APPENDIX H. Road Safety Audit and Designer's Response

Road Safety Audit Report

Proposed Roundabout along the A325 Holt Pond

Report Status 4

APPENDIX G. Swept Path Analysis

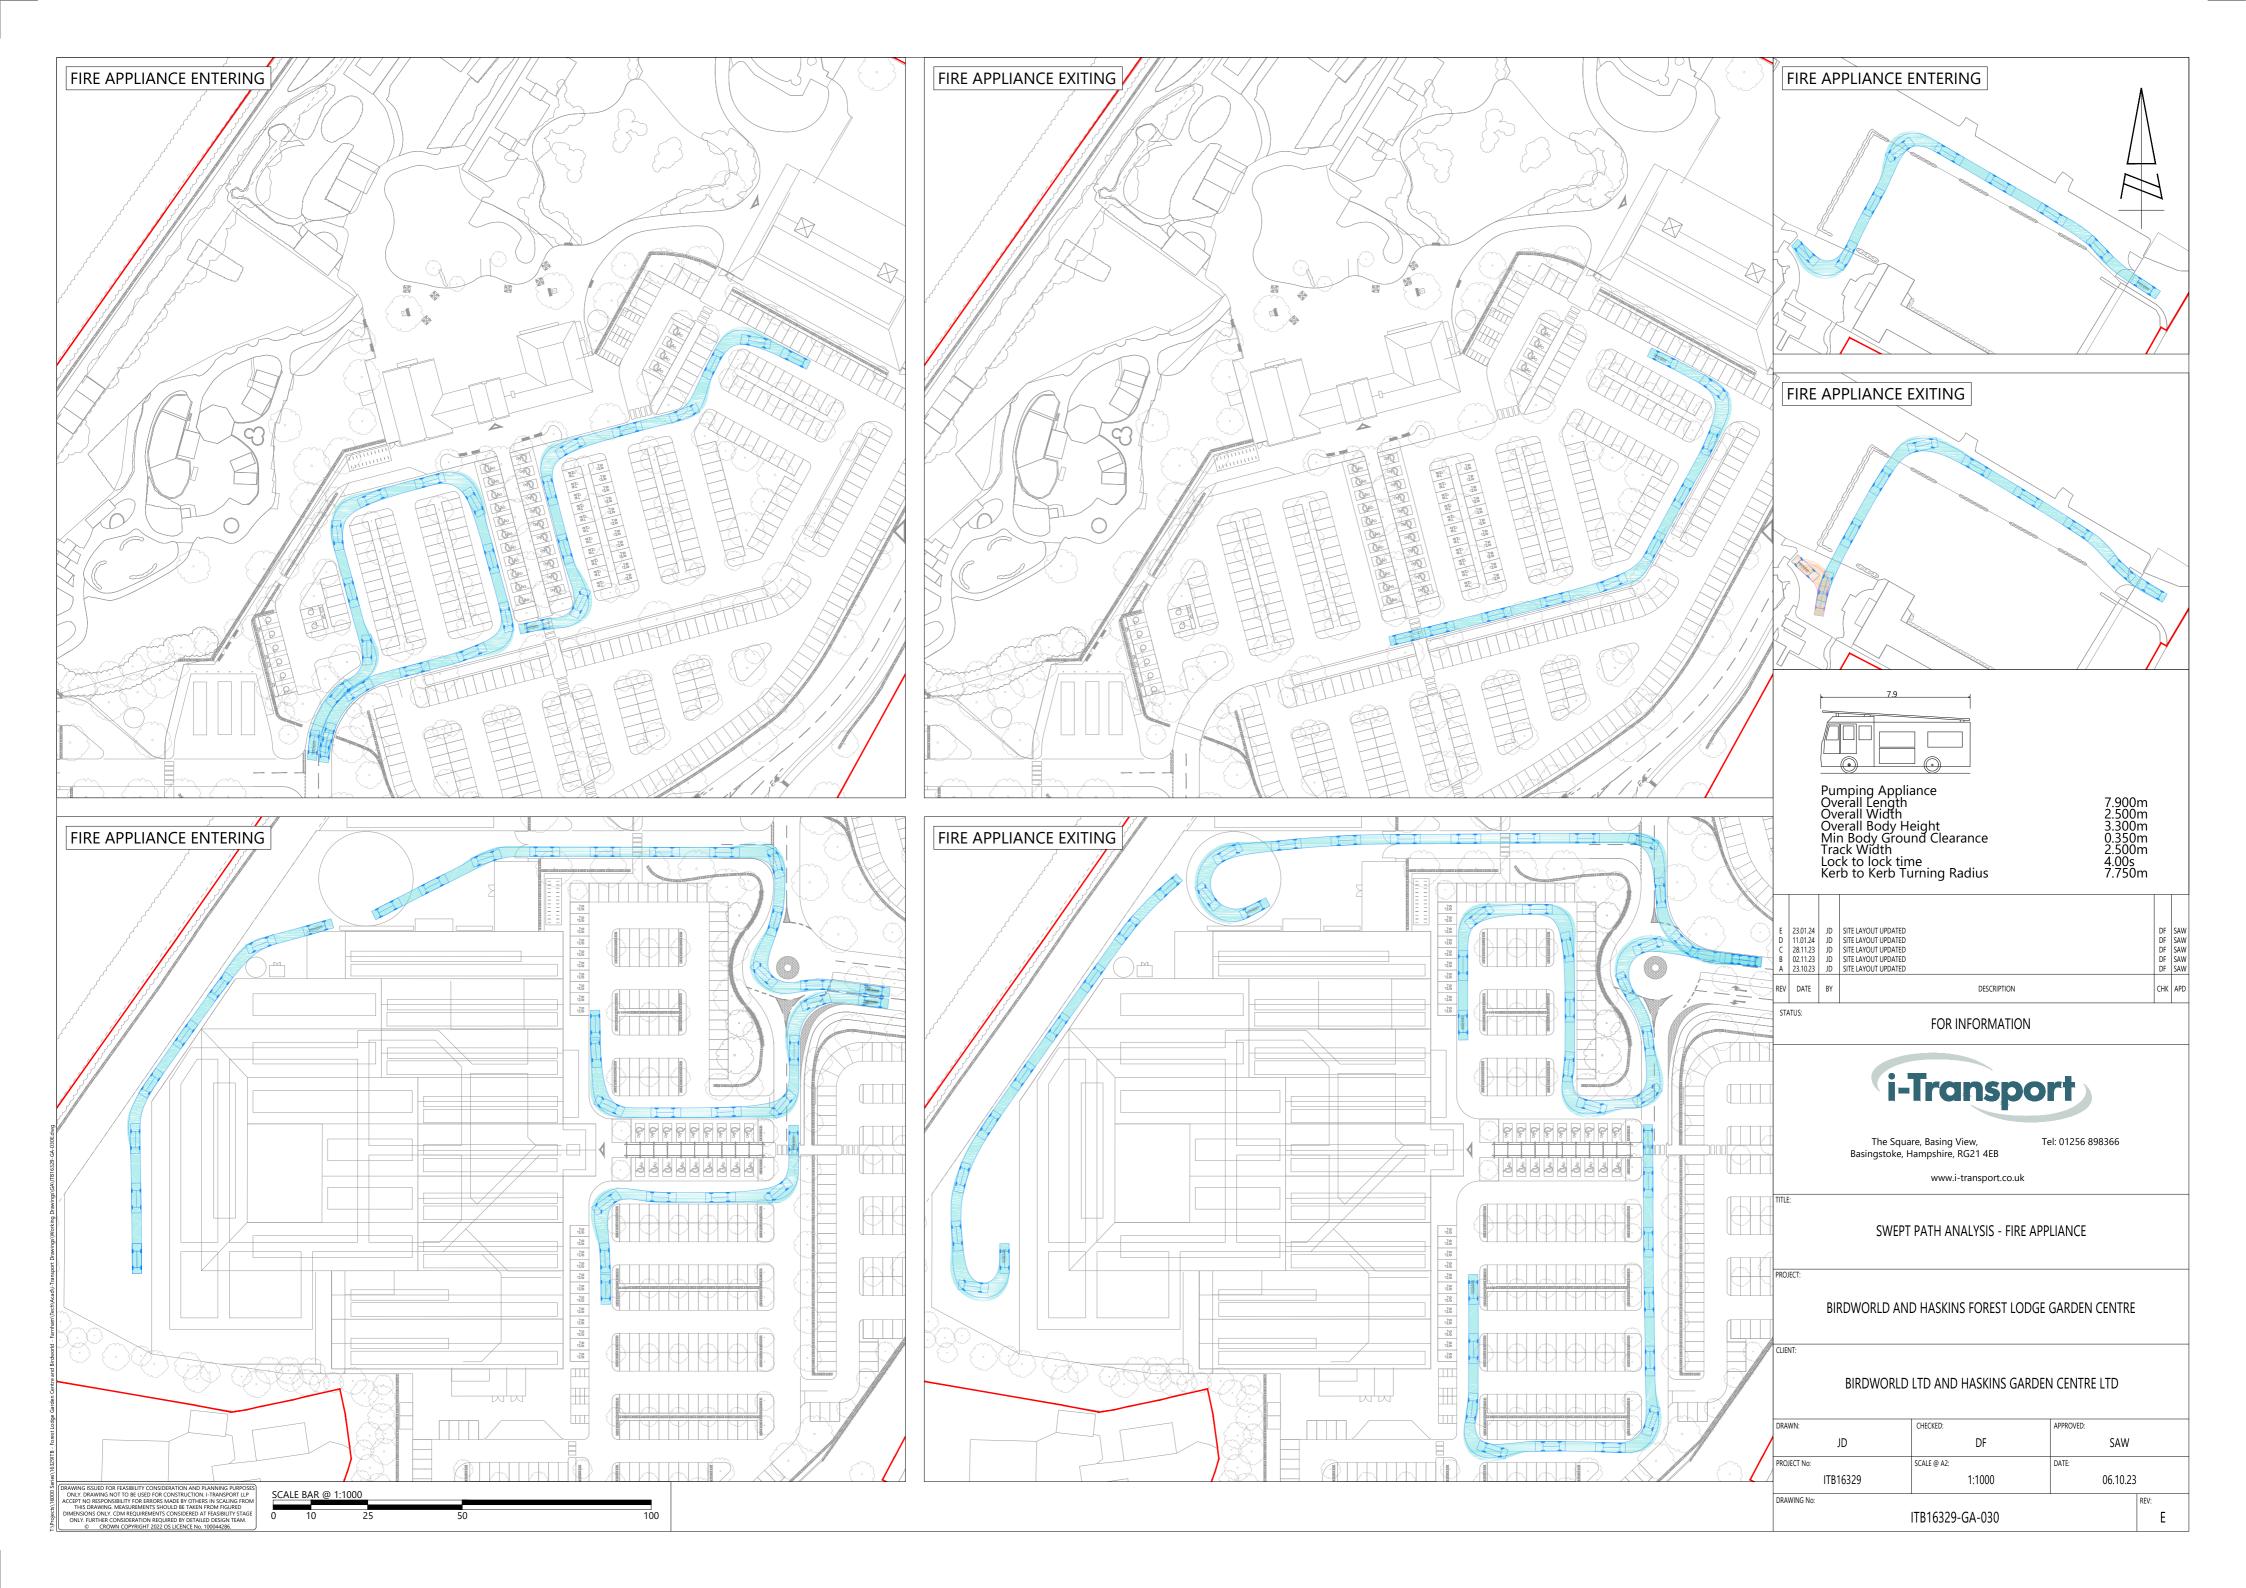
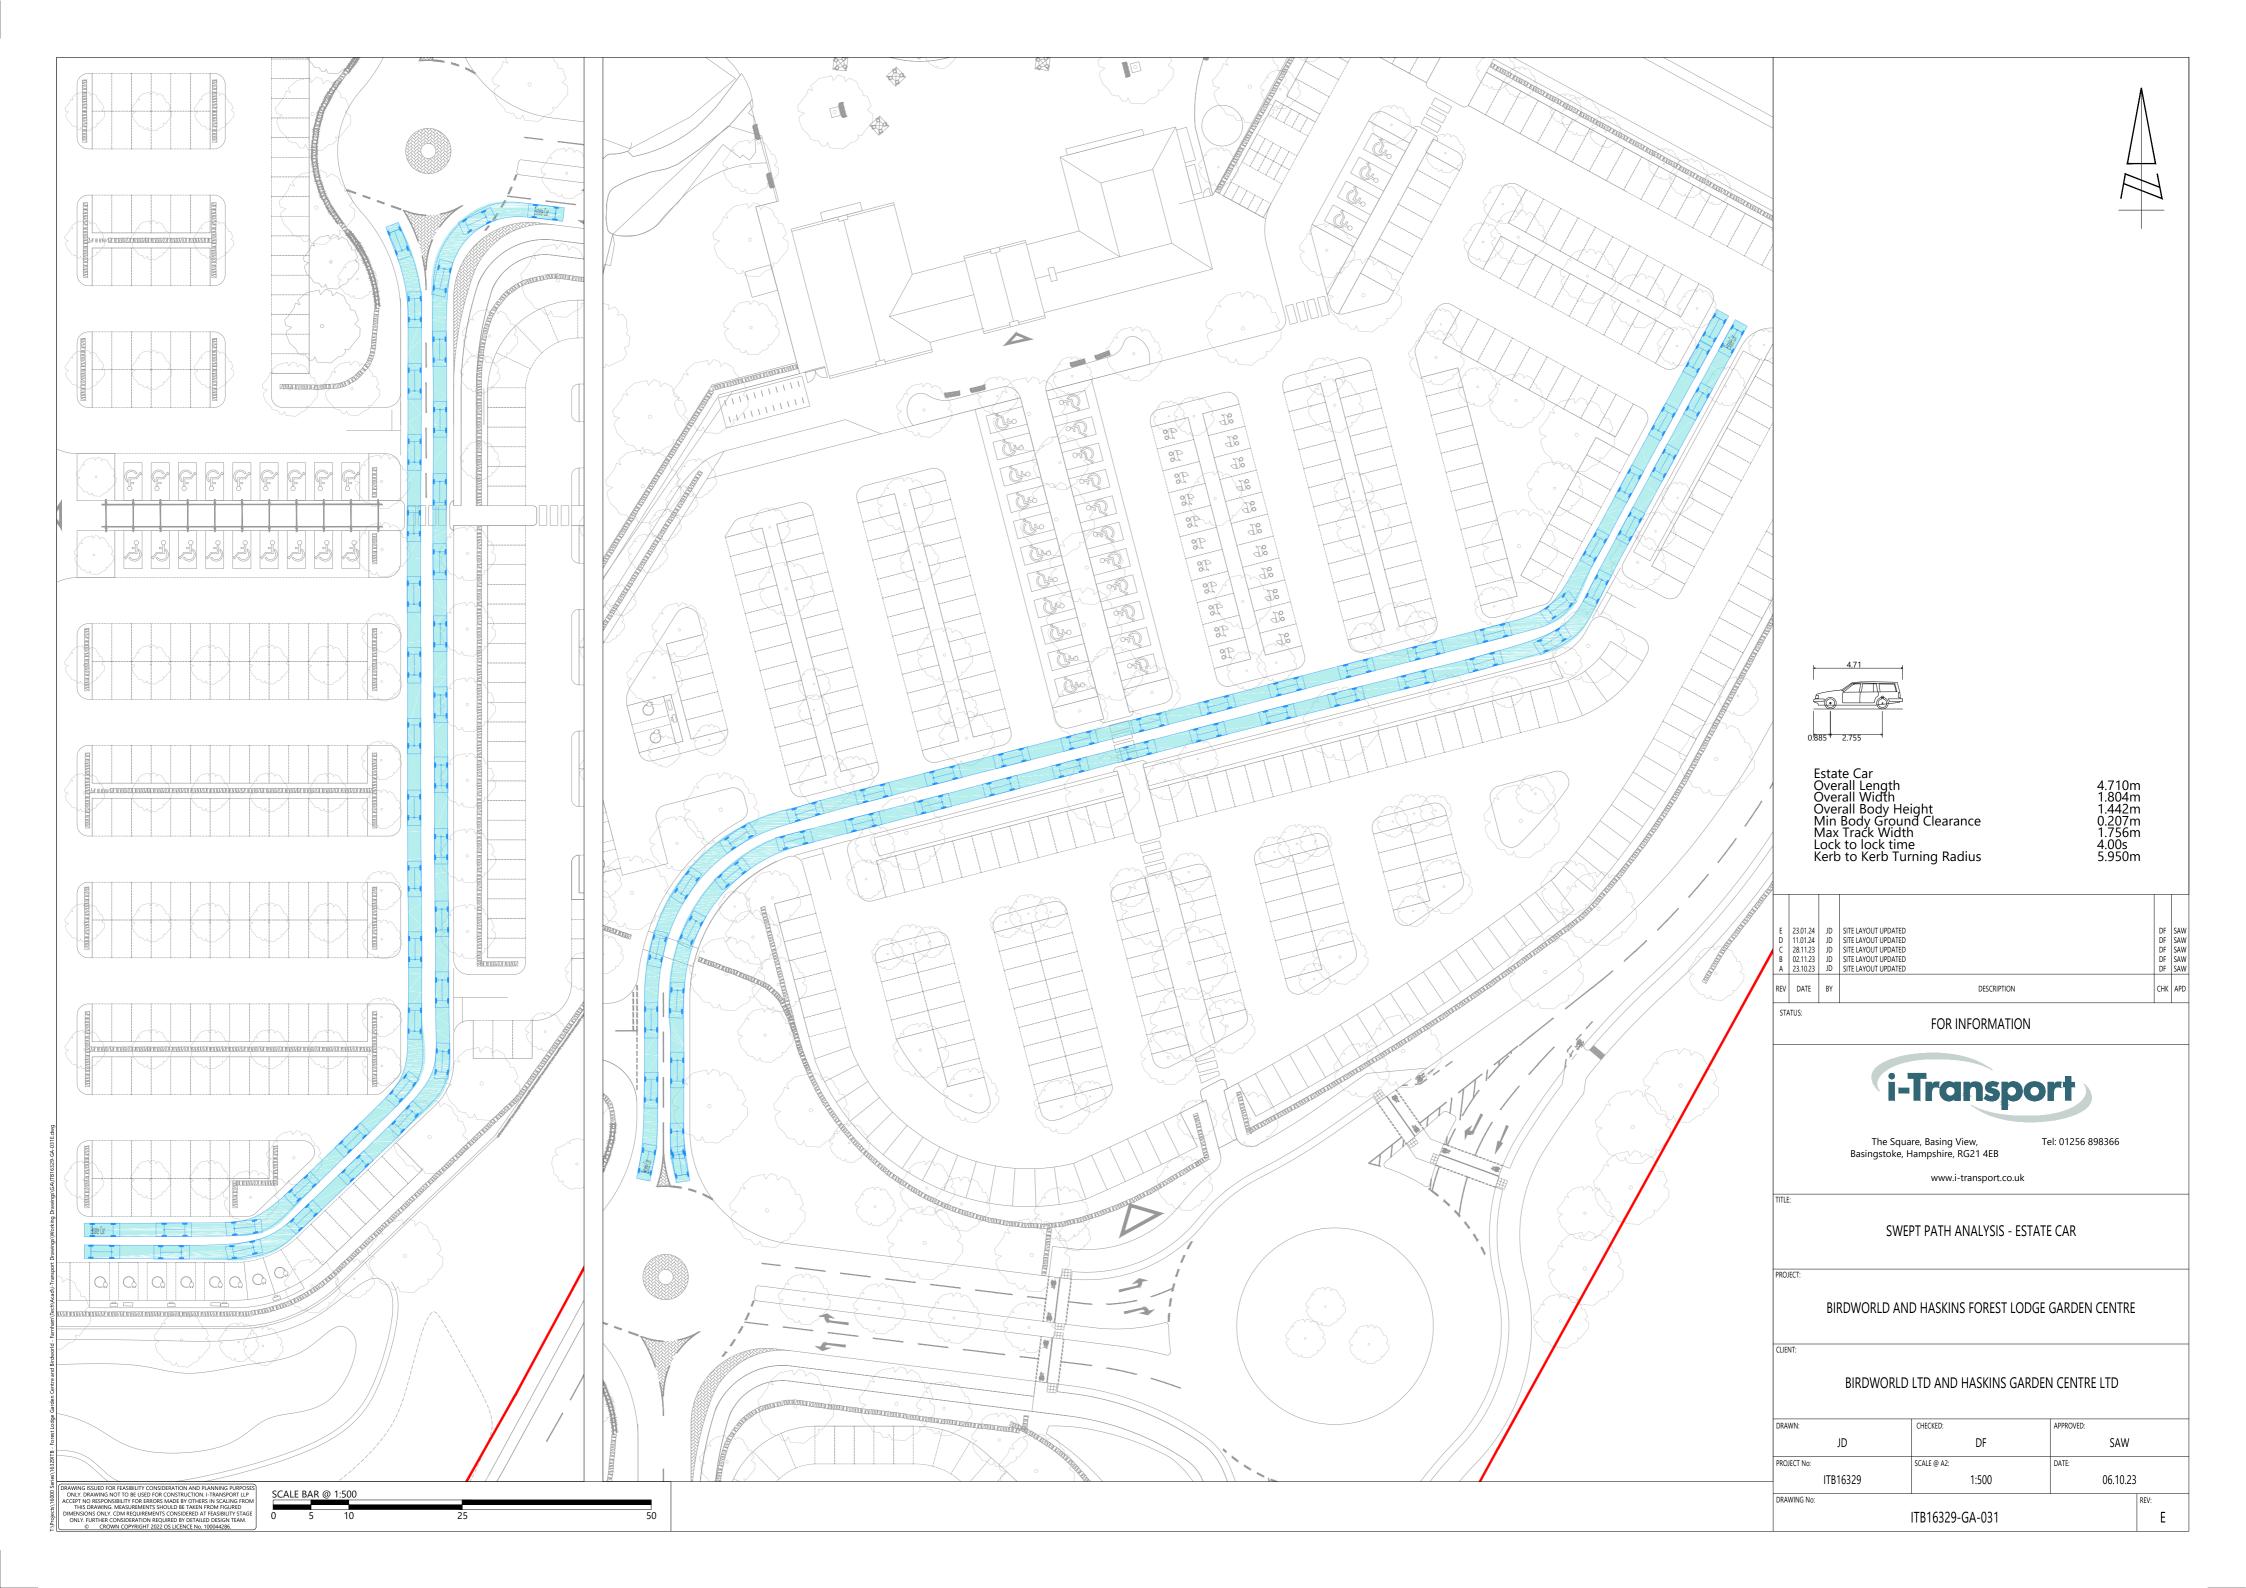
between the A325 and a mini-roundabout serving two separate parking facilities. The scheme drawings illustrate that the proposed garden centre is to be serviced via a simple priority access off the northern arm, however, no swept path analyses have been provided. The Audit Team have concerns that the HGV's will not be able to negotiate the infrastructure which could lead to sideswipe type collisions as well as the vehicles encroaching the footway increasing the risk to pedestrians.

It is recommended that the infrastructure is adequate for the expected vehicles.

Agreed – Vehicle swept path analysis of typical service delivery vehicles likely to be associated with the development has been undertaken and shown on Drawing No. ITB16329-GA-021 and ITB16329-GA-022. This demonstrates that vehicles can enter, turn and exit the internal arrangement including the service areas. Whilst is it noted that some movements result in the overrun of the opposite lane, these movements will be infrequent, in a low traffic speed environment and with good intervisibility in all directions.

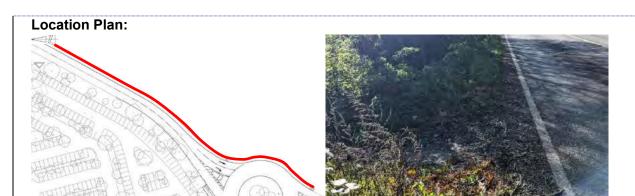
In the vicinity of the proposals, the A325 is set at a higher level than the land to the east which consists of the Alice Holt Forest. Observations indicate that although dense vegetation is present, the verge immediately adjacent to the carriageway appears to be set as an embankment and falls away abruptly. The proposals include the provision of a footway alongside the A325 which is to allow pedestrian access between a proposed redeveloped Haskins Garden Centre / Birdworld and a public right of way through the Alice Holt Forest. The Audit Team have concerns that insufficient space is present between the proposed footway and Alice Holt Forest to provide an adequate embankment which could result in rutting and failure of the footway as well as pedestrian falls and personal injuries.

It is recommended that an adequate embankment is provided.

Agree – The boundary of Alice Holt Forest is offset from the A325 carriageway by circa 7 metres and therefore ample space is present to provide a margin besides the carriageway, the illustrated footway and footway cycleway and a sufficient embankment which accords with guidelines.
